WCAP-8763-A

NEW WESTINGHOUSE CORRELATION *WRB-1* FOR  
PREDICTING CRITICAL HEAT FLUX IN ROD BUNDLES  
WITH MIXING VANE GRIDS

SUBJECT: STAFF EVALUATION OF WCAP-7956, WCAP-8054, WCAP-8567, AND  
WCAP-8762

SAFETY EVALUATION REPORT  
ON  
WRB-1 CRITICAL HEAT FLUX CORRELATION

Figure 1 Cross-Sections of CHF Test Sections

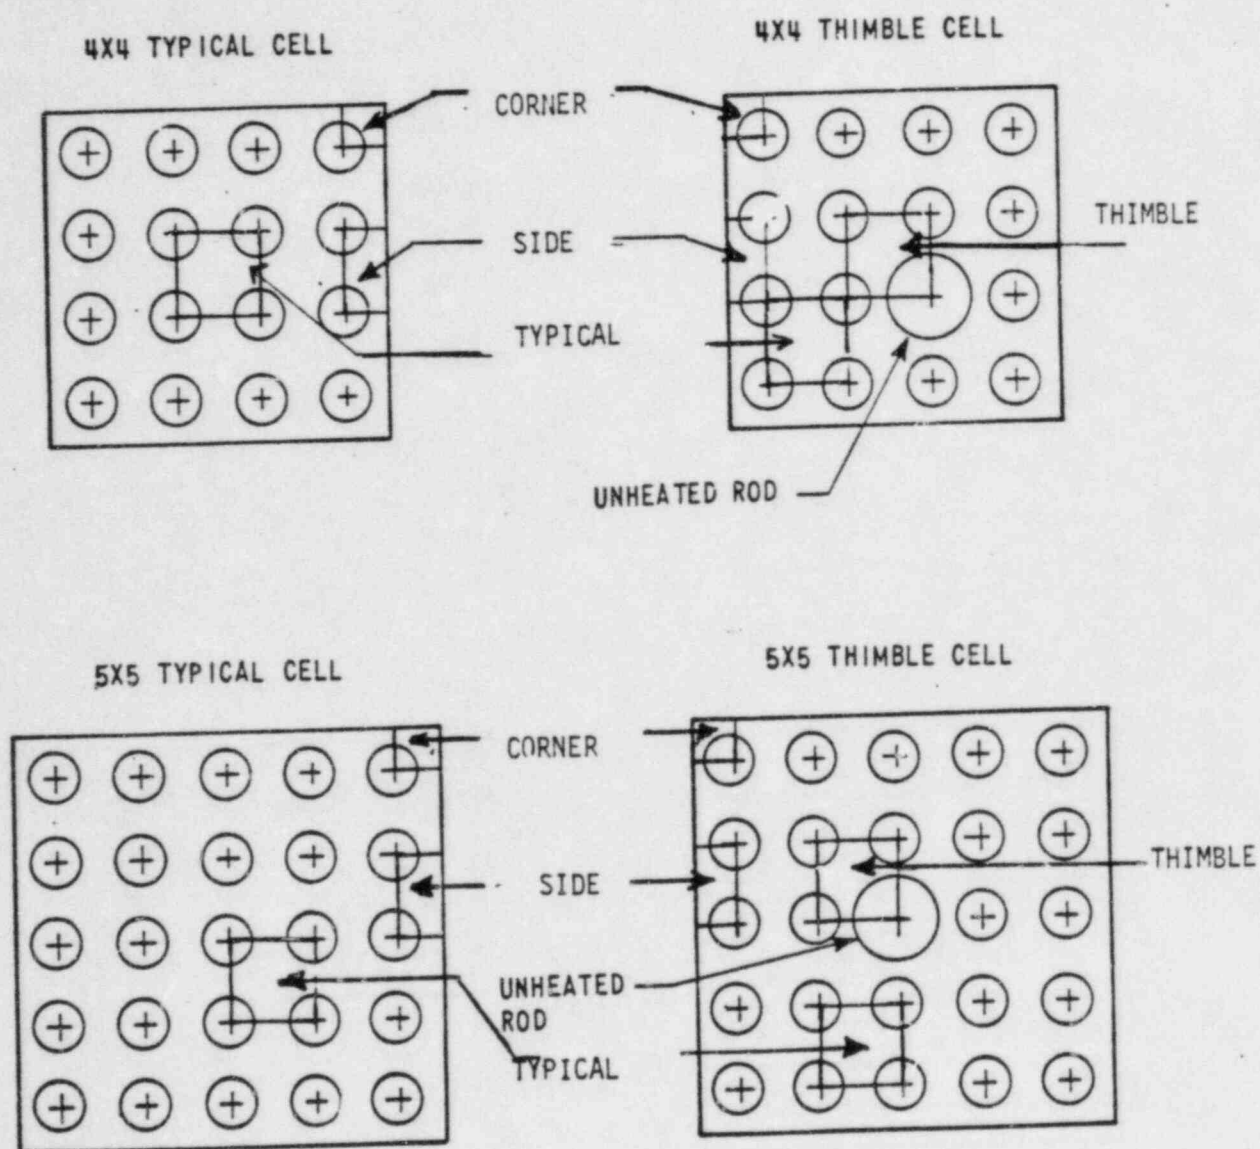
1. Provide a complete description of how the local conditions for the WRB-1 correlation were calculated in developing the correlation. The description should include a discussion of: the subchannel code used; subchannel modeling; axial nodalization; and input assumptions (such as Thermal Diffusion Coefficient, friction factors, spacer grid loss).

As in design, the THINC sub-channel code is used for the data reduction. The subchannel modeling is shown in the attached figure 1. The length of the axial nodes and other input variables are given in the attached table 1. The friction factors are calculated by the methods presented in Reference (2).

FIGURE 2. AXIAL GRID AND CHF DETECTOR  
 LOCATION FOR 14 FT. TEST SECTION WITH  
 20" GRID SPACING

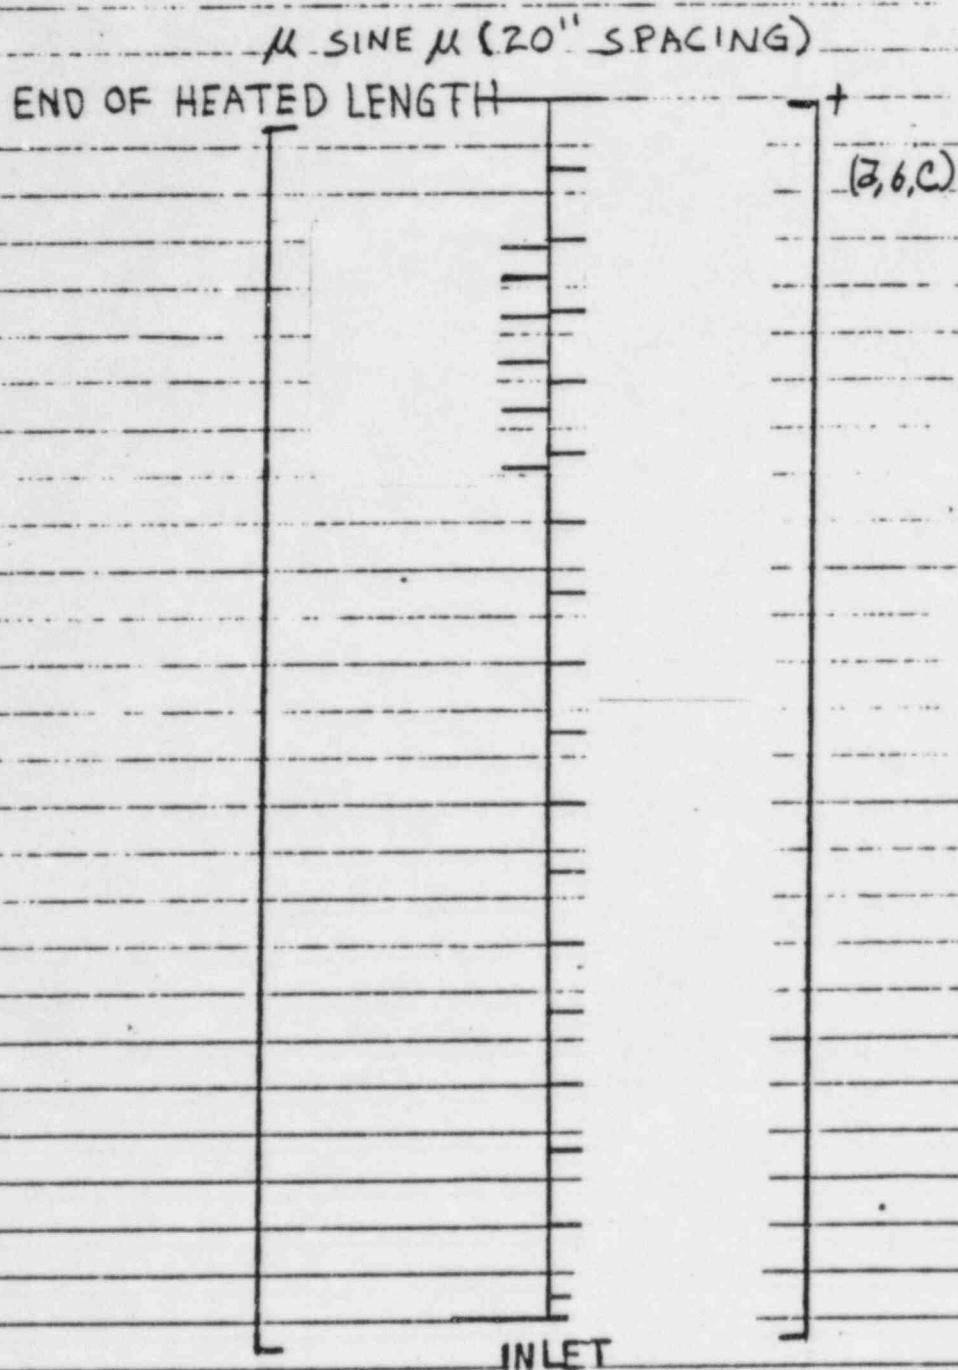
10. Provide the grid locations and thermocouple locations for the test series A-10. This information is not presently available because these tests were not previously published.

Figure 2 gives the locations of the grids and thermocouples for test series A-10.

Figure 3. 14 Ft. Heater Rods Axial Heat Flux Distributions

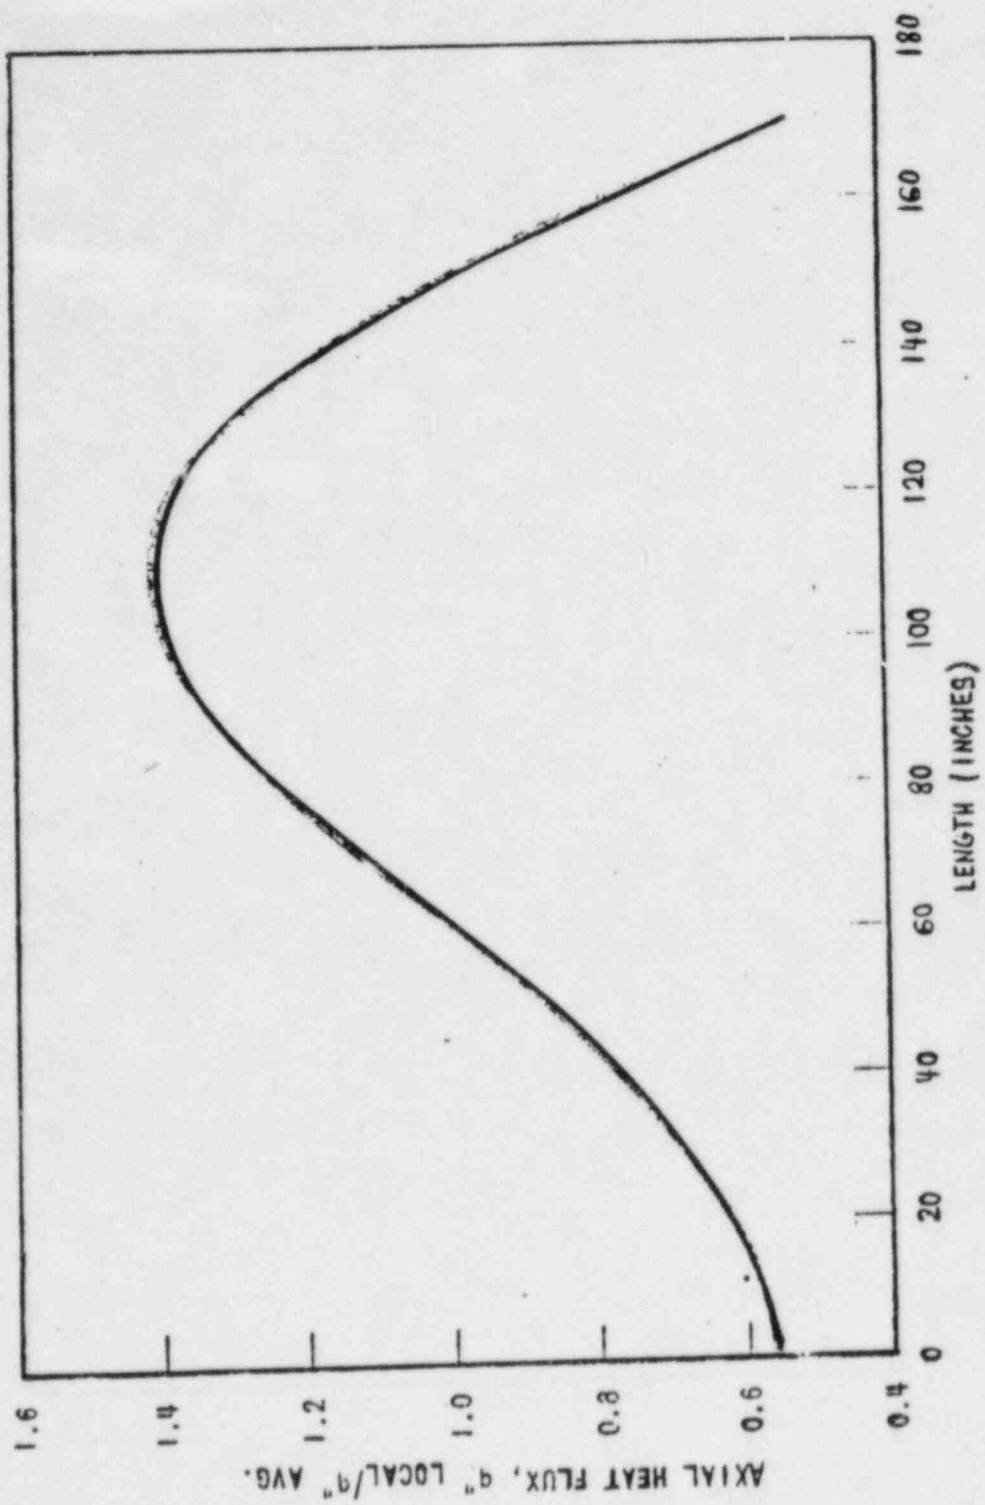
11. The staff has been unable to verify the results of the A-10 test series. We believe that this is because the USINU power distribution presented in WCAP-8762 and in the referenced reports does not have sufficient detail to allow an accurate representation in the COBRA IV code. Provide a more detailed graphical or numerical representation of the power distribution for test series A-10.

The axial heat flux profiles for test series A-10 are the same as for test series A-9, A-11, A-12, A-14, A-16 and A-17. Figure 3 is a plot of this profile.
